Arlington County Historical Affairs and Landmark Review Board, Design Review Committee
January 2024 Pre-Meeting Letter

REQUESTED REVISIONS TO HALRB CERTIFICATE OF APPROPRIATENESS
17 March 2021, Case 19-27A (HPCA21-00007)

**WALKER CHAPEL HISTORIC CEMETERY PROJECT (HCP)
RE-INSTALLATION OF SITE ELECTRICAL EQUIPMENT**

Re-installation as shown in CoA Landscape Lighting and Planting Plan drawings

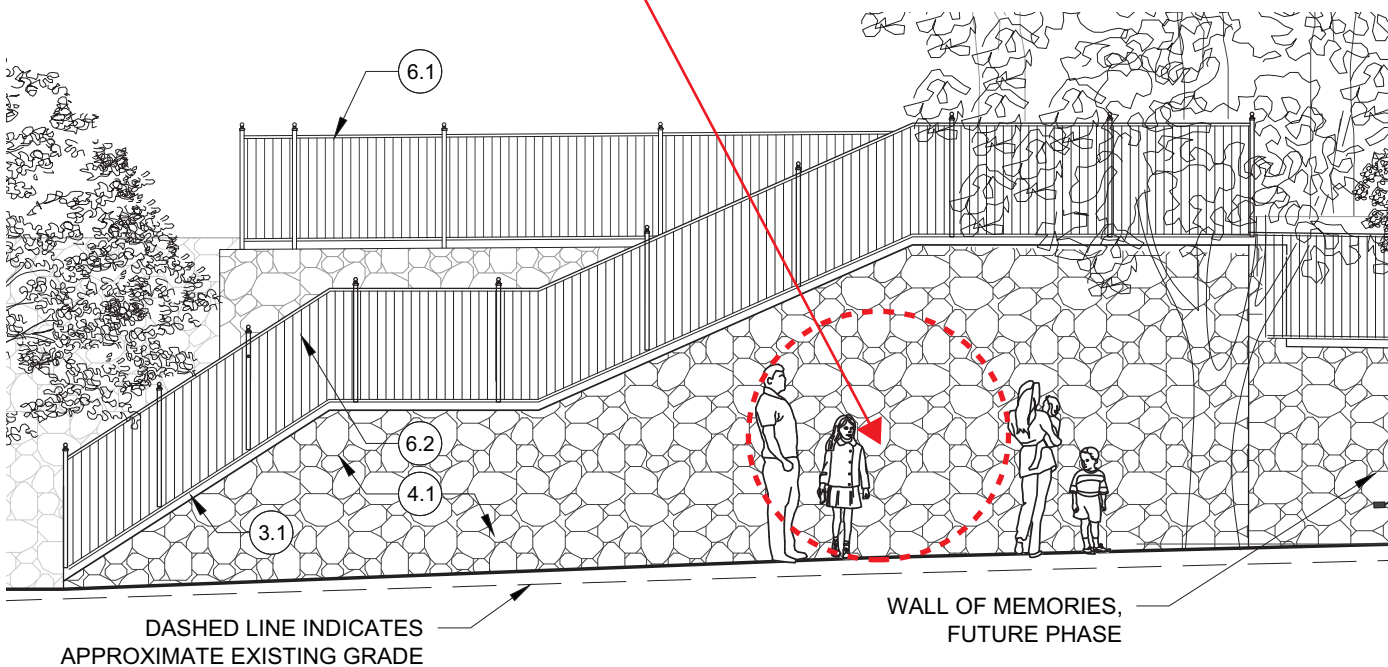
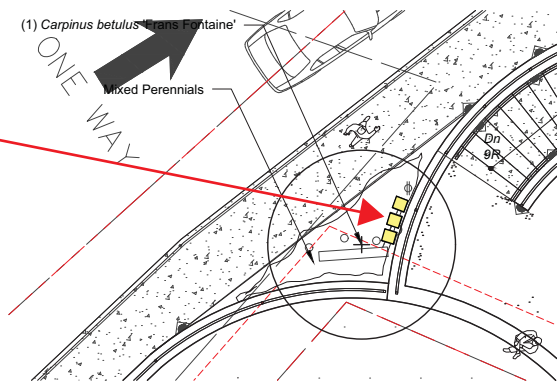
However, no indication of re-installed site electrical panels on CoA Landscape Elevations drawing

AS- CONSTRUCTED CONDITION

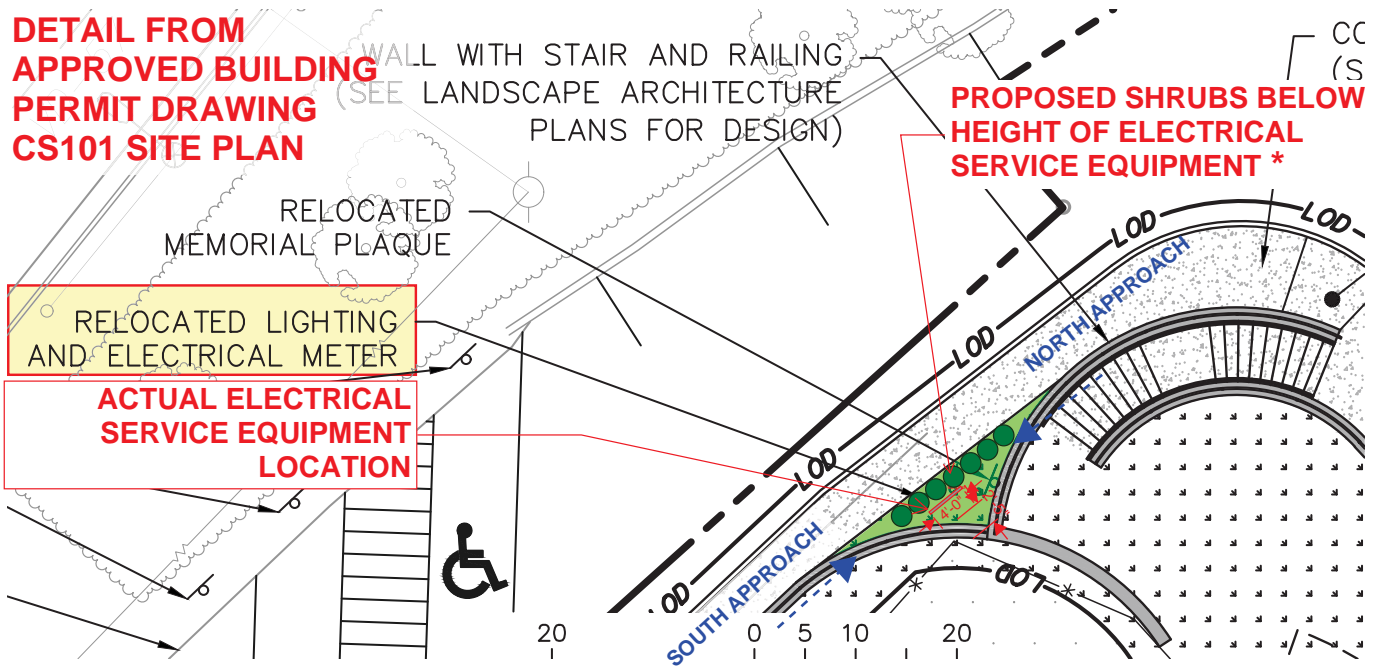
The Owner Construction Phase Representative approved installation of the electrical service equipment on a freestanding support frame permitting continuity of maintenance access to the new stone retaining wall. The as yet-unconnected electrical service equipment is mounted on a frame consisting of narrow, premium quality stainless steel channels. The electrical service panels are either stainless steel or soft-gray factory painted metal, and the flexible and rigid conduits from the panels to the underground conduits are also gray in color. The entire installation blends well with the new natural stone retaining wall behind it and since the equipment is not attached to the wall, it is more respectful of it.

*** NOTE:** Only during recent conversations with Dominion Energy did we learn of their strict clearance requirements around their electrical meter; shrub planting as shown here is not permissible under this criteria.

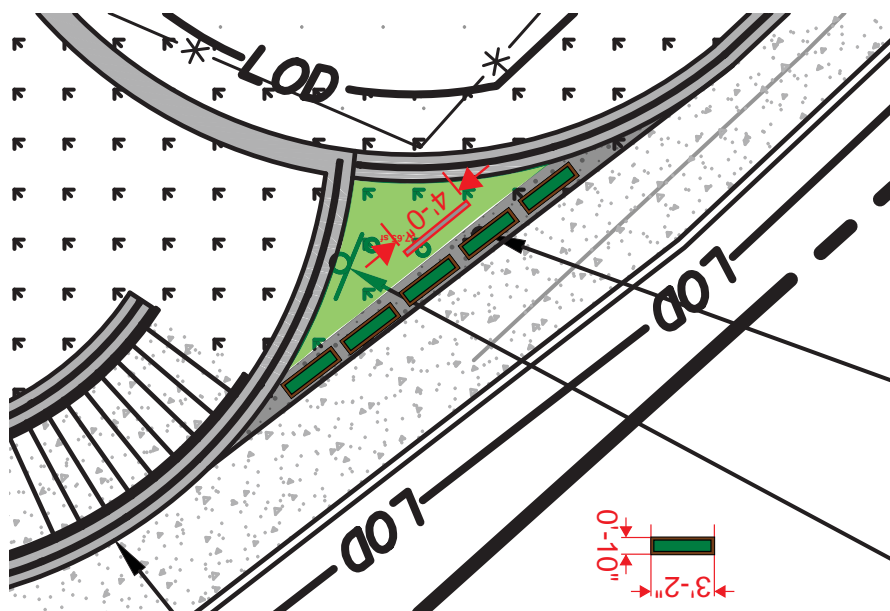
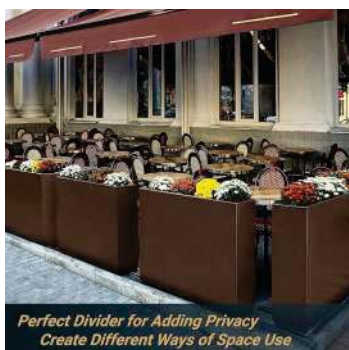
OPTION 2: Procure and position manufactured privacy screen plant boxes set on stone mulch in the 2'-5" area in front of the service panel installation. The Wallowa Metallic Heavy Planters are not fixed; they can be moved for major-task electrical service access.

The metal cabinets are available in four colors: coffee (shown); black; gray; and white.

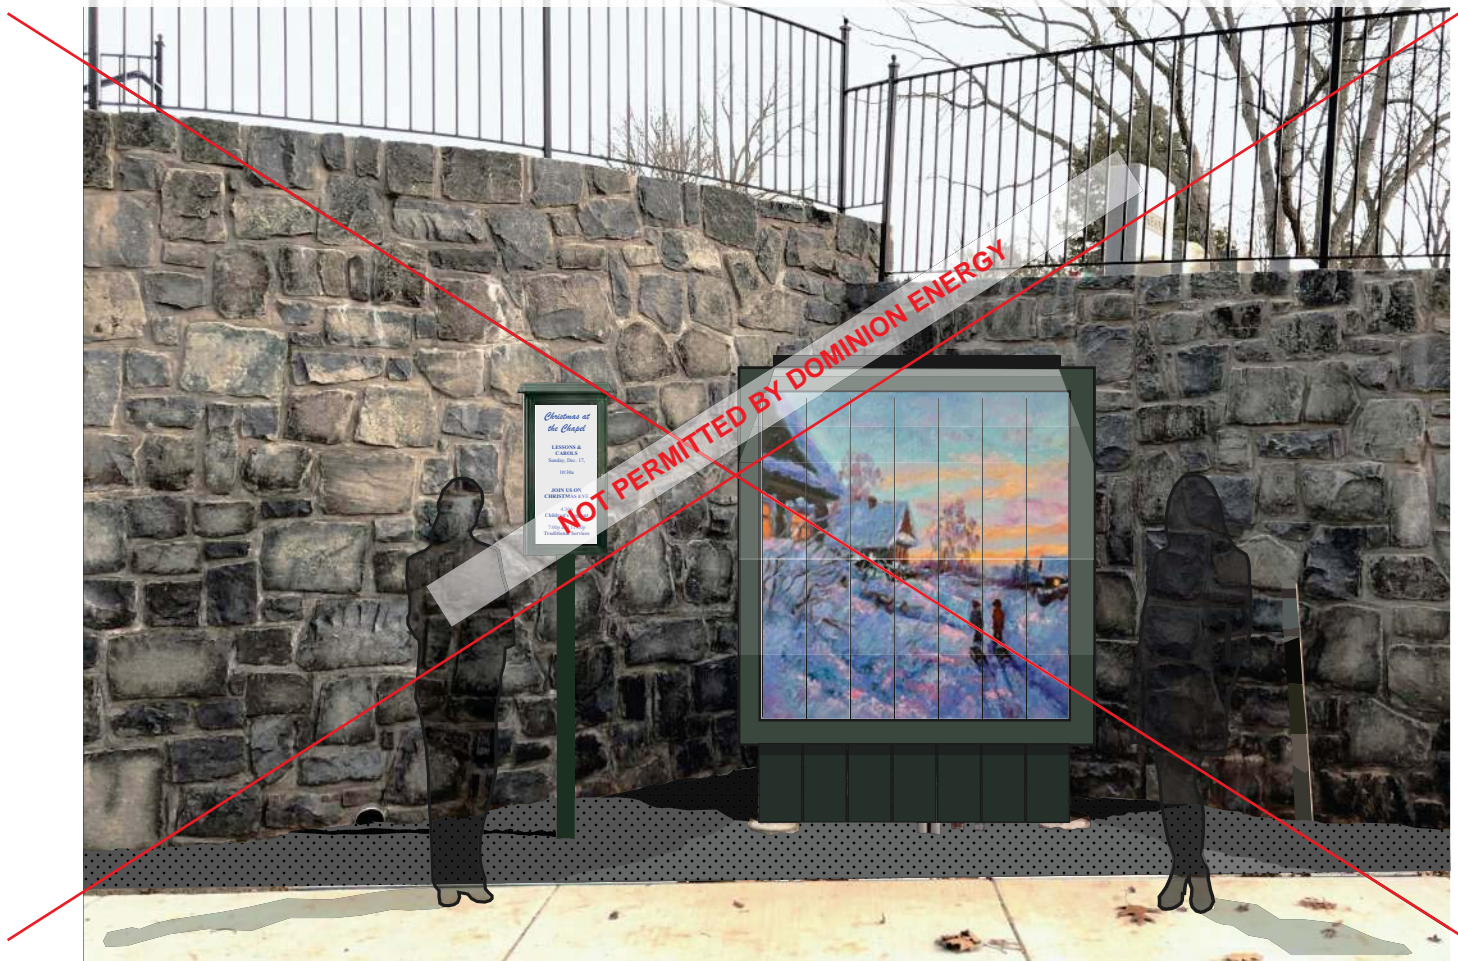
Conceal the as-constructed electrical equipment frame with a lightweight, non-conductive display frame using fiberglass channels and PVC finish boards and panels. This gravity load of the display frame would be carried by the electrical equipment frame and would not touch the ground, allowing the display frame to act as a floating visual element against the natural stone backdrop of the retaining wall. The display frame would only conceal the electrical equipment frame, and not hinder access to the electrical service cabinets.

Linear LED art lighting will be attached to the top of the display frame. Hanging from inside the head of the display frame will be changeable, printed PVC mesh fabric. Just below the attachment head, the fabric will be cut in strips to allow for access to the electrical equipment; each display strip will have weighted ends to minimized wind-driven fluttering. The church will stock a minimum of four display hangings with graphics depicting the four seasons (or different church seasons). This will also serve as an opportunity to share banner graphics of church and community events, including the work of groups using church facilities such as the McLean Art Society and the Walker Chapel Preschool. It could also be used to hang banners promoting musical concerts and other scheduled community events occurring at Walker Chapel. A PVC panel skirt will be fixed to the base of the support frame, turning the corners at both side edges to conceal conduits.

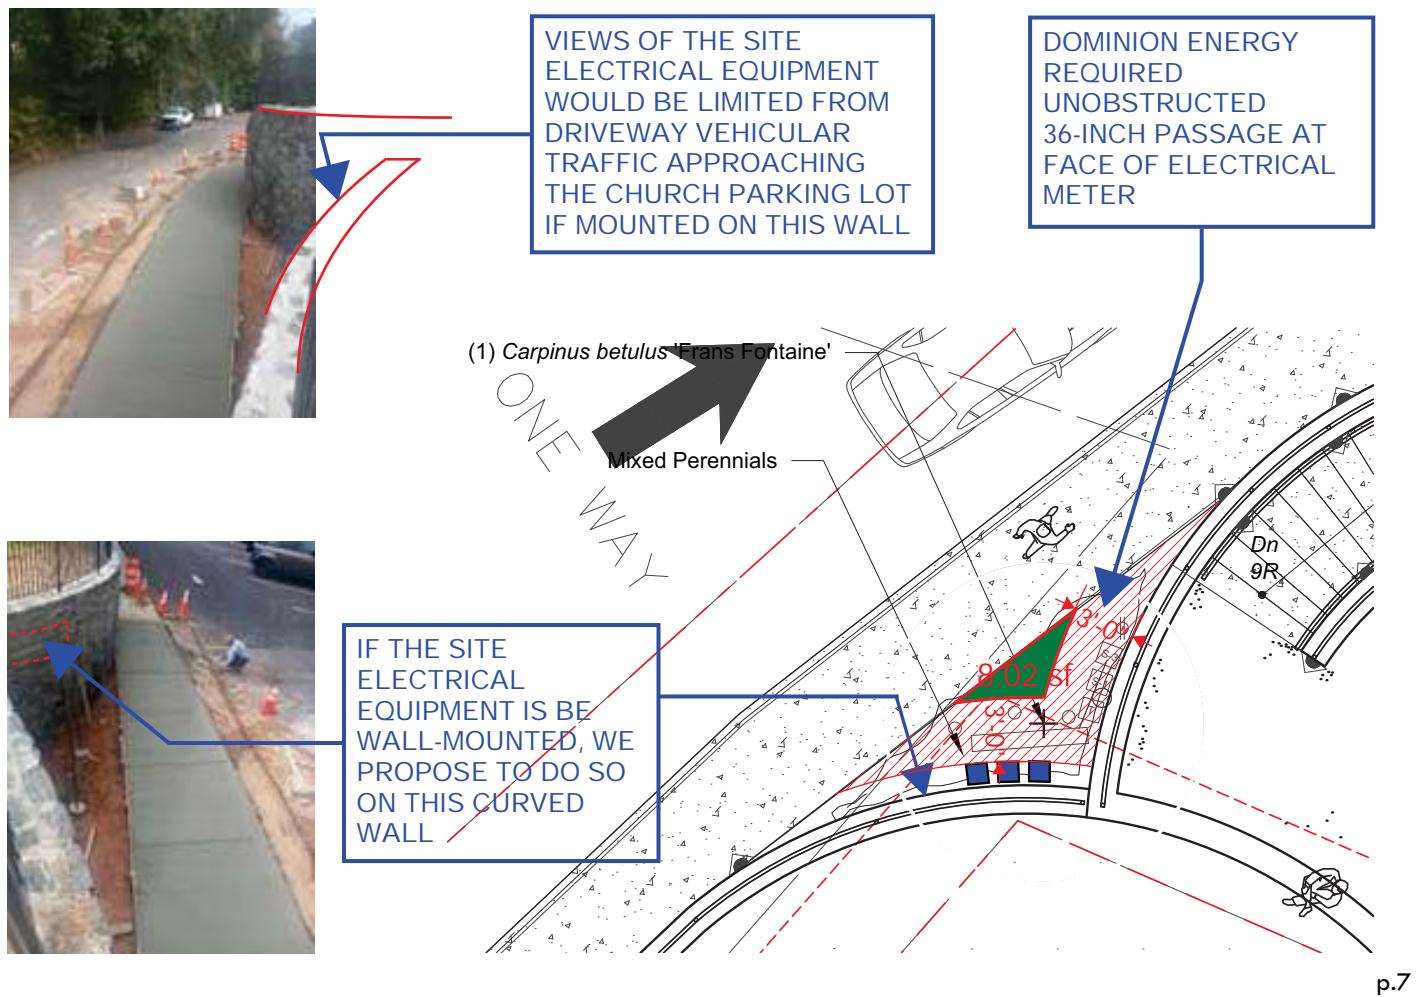
OPTION 4: This option relocates the site electrical equipment to the face of the new retaining wall (but in a different location than shown in the originally approved CoA--more about this below).

This means the freestanding service panel rack will be removed and the service panel components will be attached to supporting channels behind the equipment. The conduit-enclosed circuits, both incoming from Dominion Energy and distribution circuits into the cemetery, will be moved so that they terminate in ground-level junction boxes. The wall-mounted components will then be re-connected to their circuits within the junction boxes.

The graphic below shows the proposed location of the wall-mounted equipment components. This location is proposed because the driveway vehicular traffic flow is from left to right in the plan image; by placing the electrical equipment on the cemetery wall rather than the staircase wall, views of the equipment are better blocked. Once installed, consideration will be given to using plants to further obscure the equipment from view.

THIS PARTIAL PLAN AND PARTIAL ELEVATION ARE TAKEN FROM THE PROJECT LANDSCAPE ARCHITECT'S DRAWINGS, MODIFIED TO SHOW THE PROPOSED WALL-MOUNT OPTION

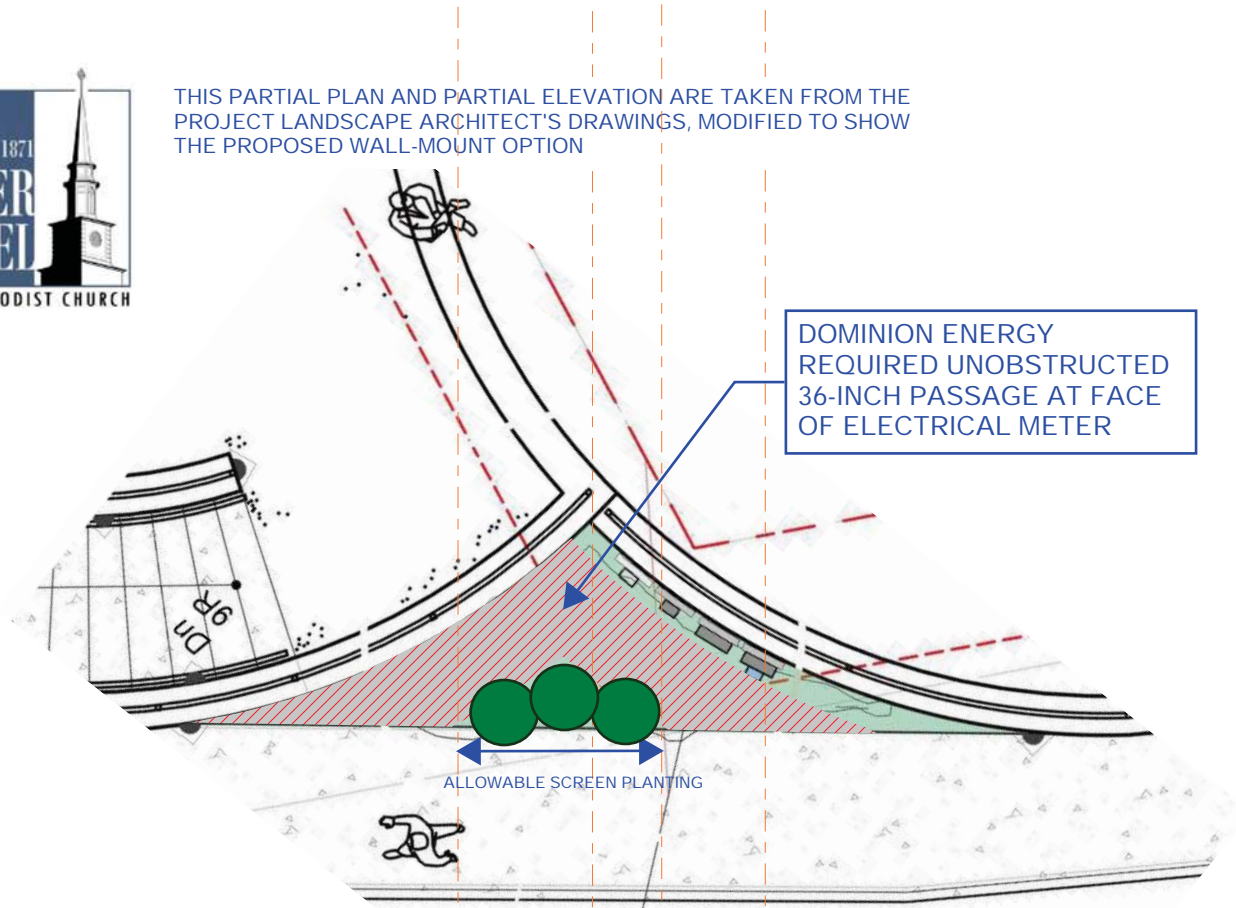
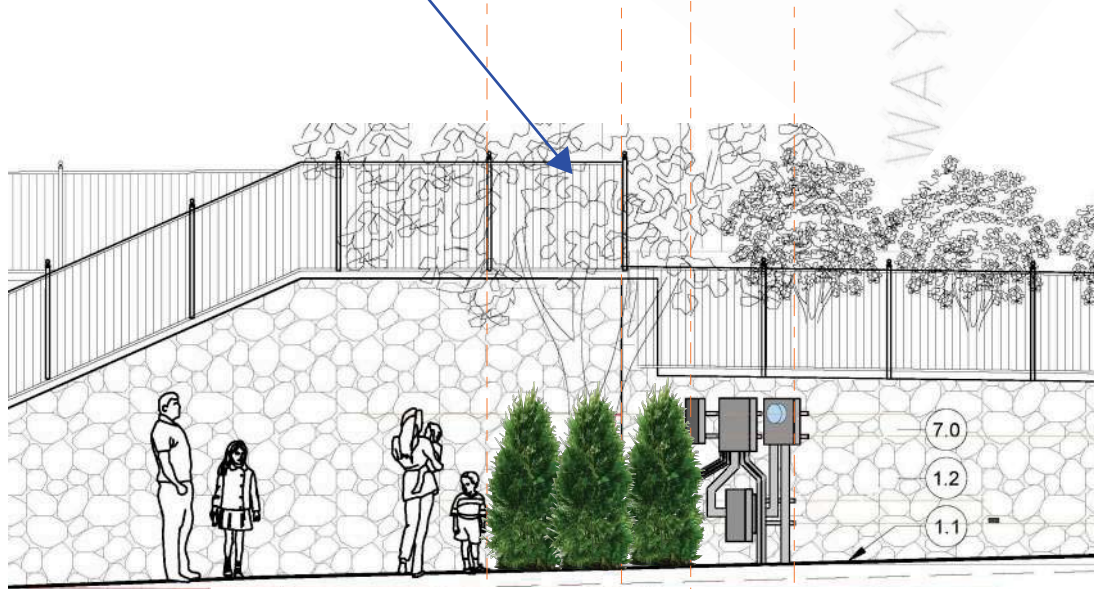
TREE PLANTING NOT POSSIBLE DUE TO UNDERGROUND ELECTRICAL CONDUITS

TRUE ELEVATION FROM DRIVEWAY AND SIDEWALK
 (ACTUAL CONFIGURATION OF PANEL BOXES MAY VARY DEPENDING ON
 ELECTRICAL CONTRACTOR'S JUDGMENT RELATED TO EFFICIENCY AND
 NATIONAL ELECTRICAL CODE MINIMUM REQUIRED CLEARANCES)
